## ORIGINATION FORM

### Proposed Revisions to a Standard Plans Index (Please provide all information — Incomplete forms will be returned)

Index Number: 715-003  
Sheet Number (s): All (1-3)  
Index Title: Utility Conflict Pole

**UTILITY CONFLICT POLE**

LIGHT POLE - ELEVATION

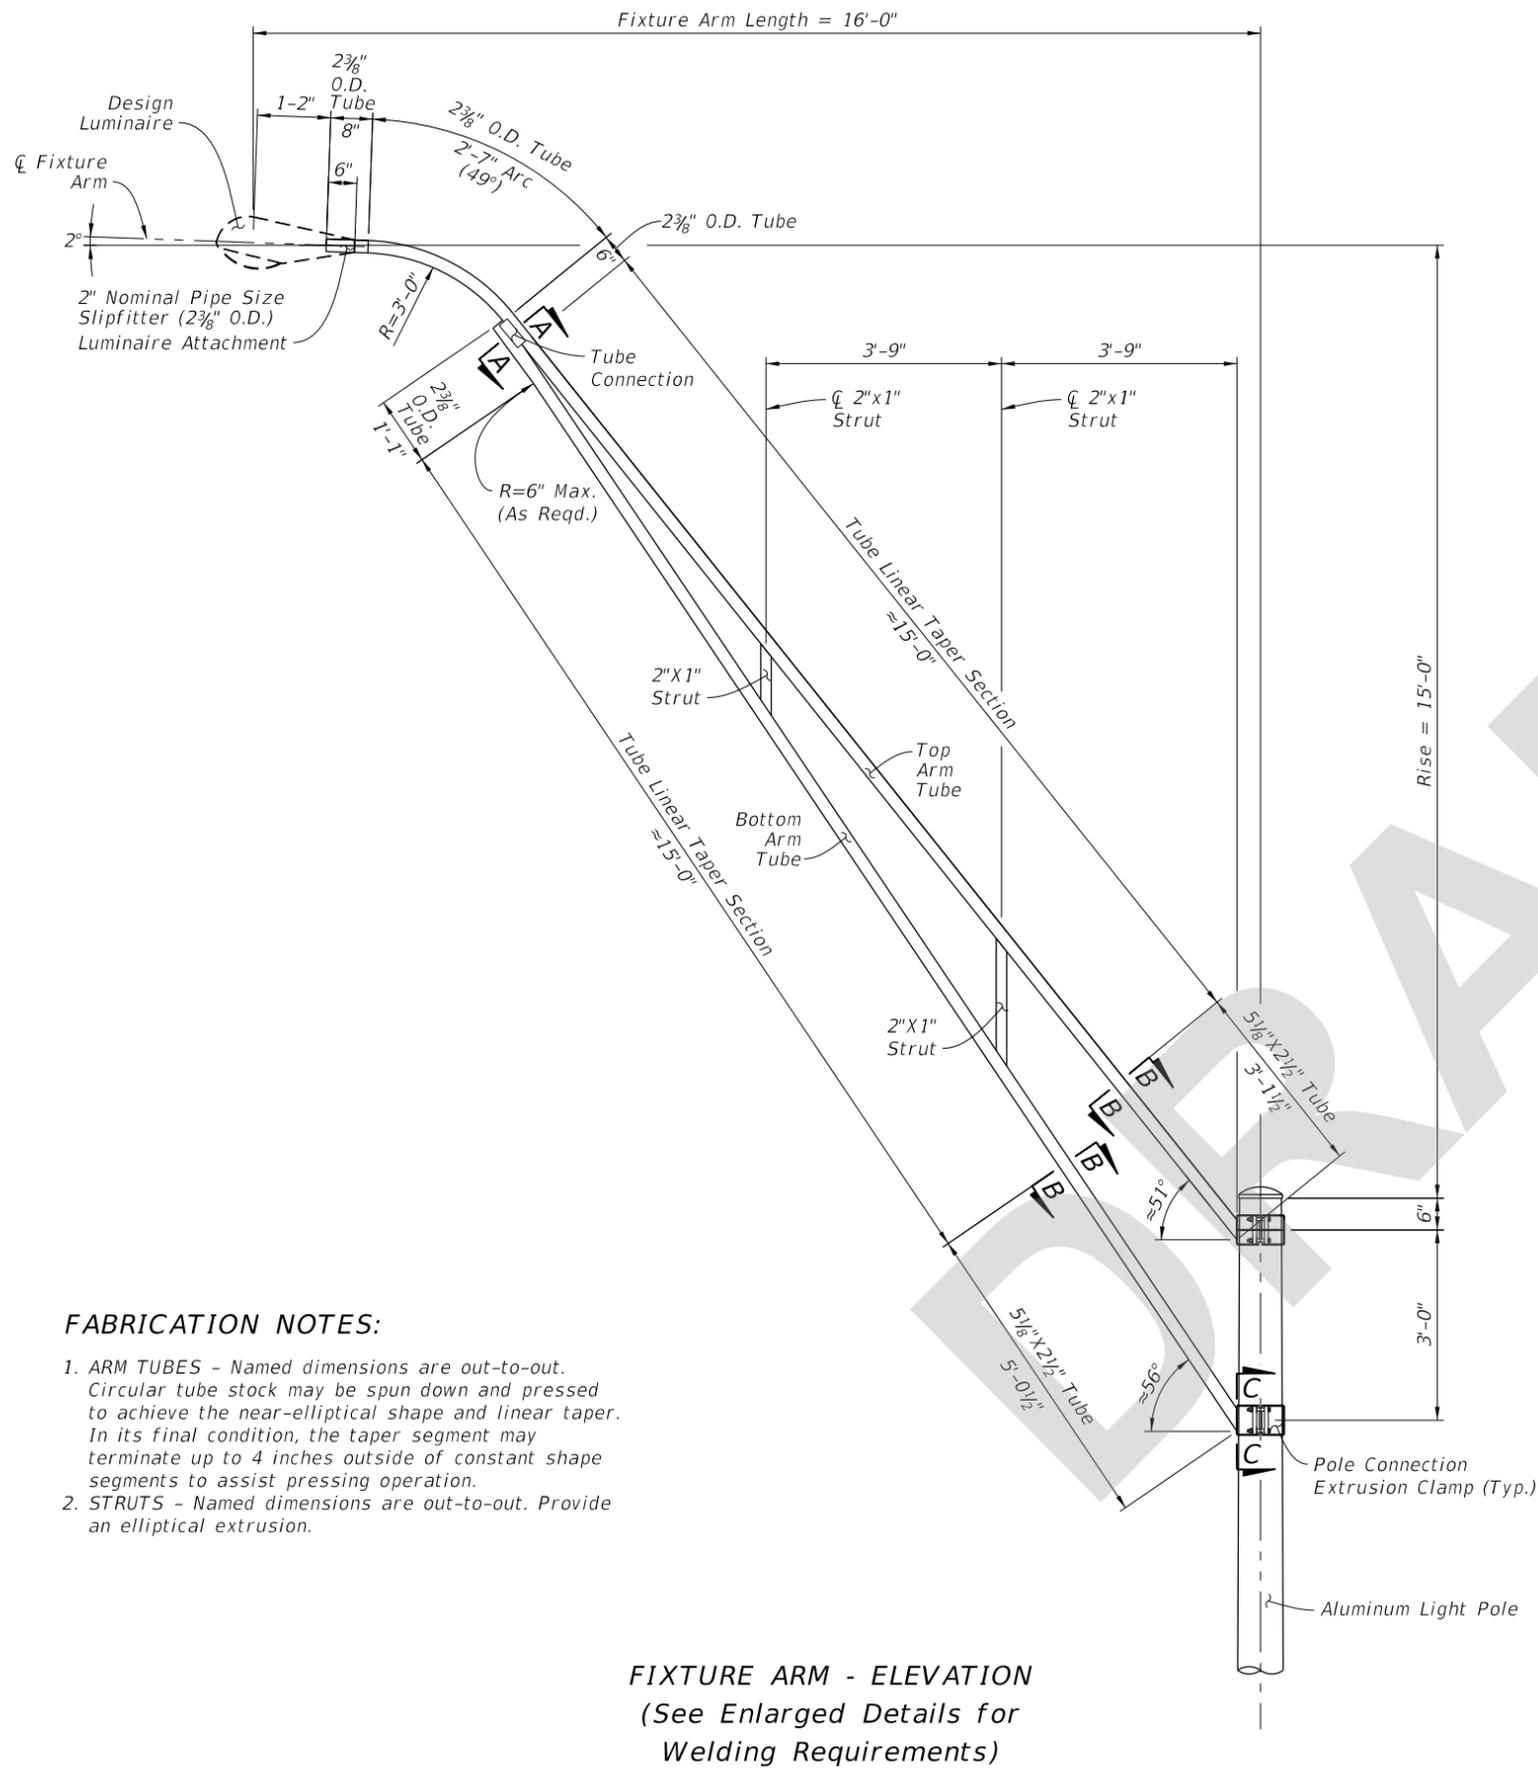
New Standard Plans Index for a different light pole type.

This new pole type has fixture arm dimensions of 16-foot horizontal by 15-foot rise to assist designers with avoiding overhead power lines and other utilities when conventional poles won't fit these project constraints.
